FINAL
YEAR 5 (2018) ANNUAL MONITORING REPORT
BEAR CREEK (PHILLIPS SITE) RESTORATION PROJECT

Chatham County, North Carolina
DMS Project No. 26 (Contract No. 5715)
DWR Project No. 0713-94
SCO No. 09-07726-01A

RE: Bear Creek (Phillips) Monitoring (DMS Project # 26, Contract #5715)
Final MY5 (2018) Annual Monitoring Report

2A

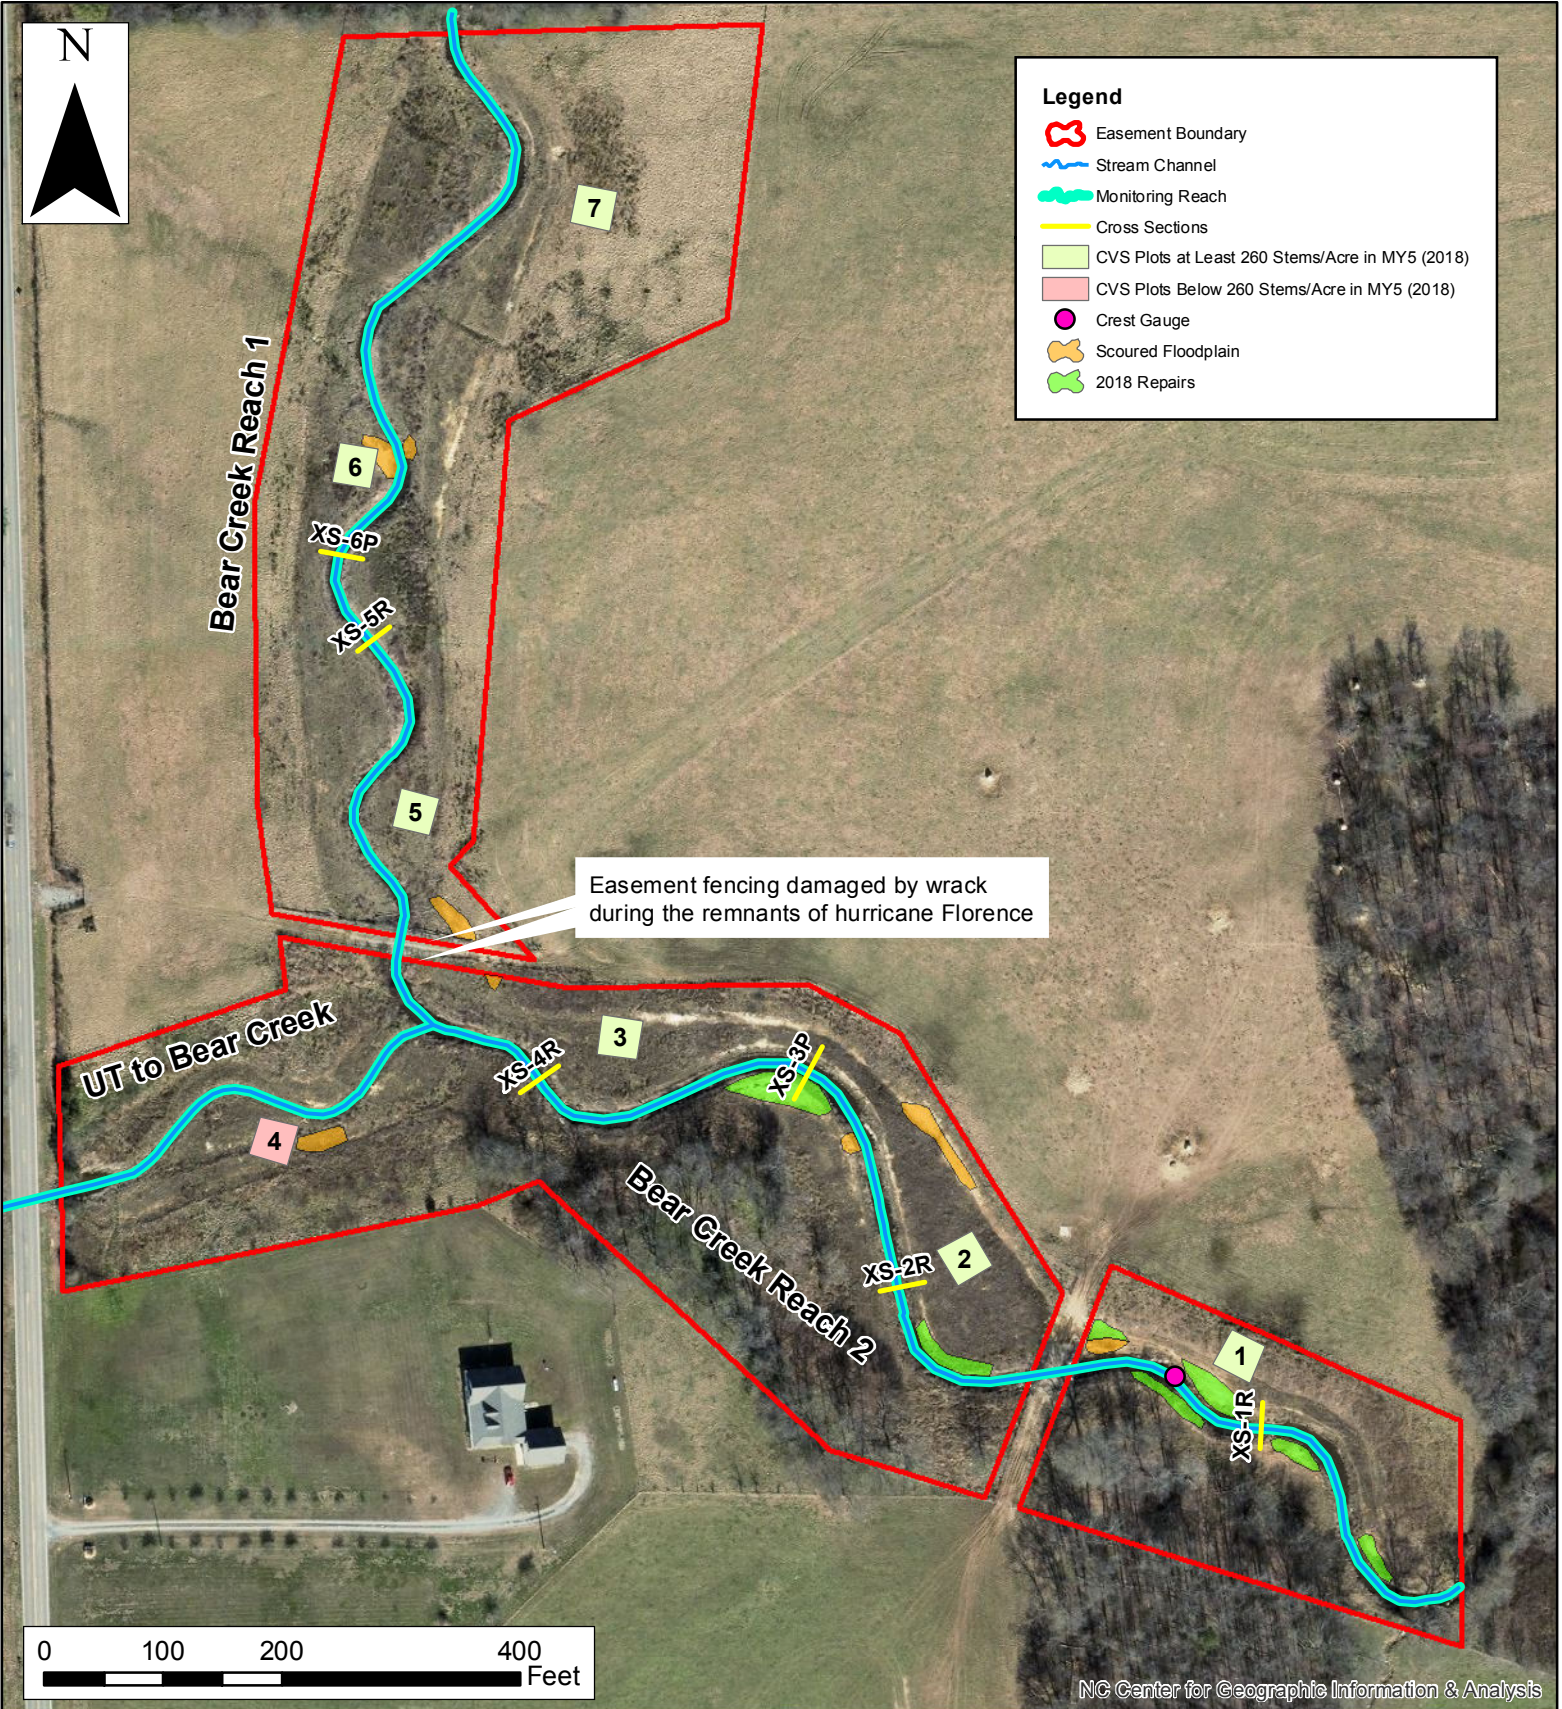
- e. Add a row for “Beaver Management” starting May 2018 to present between MY4 and MY5.
This row was added.
6. Appendix B:
 - a. Figure 2A: Color used for Stream Areas of Concern is too similar to the color used to depict the 2018 Repairs on Figure 2B. Please change.
The color used for the 2018 Repairs shapefile was changed to green.
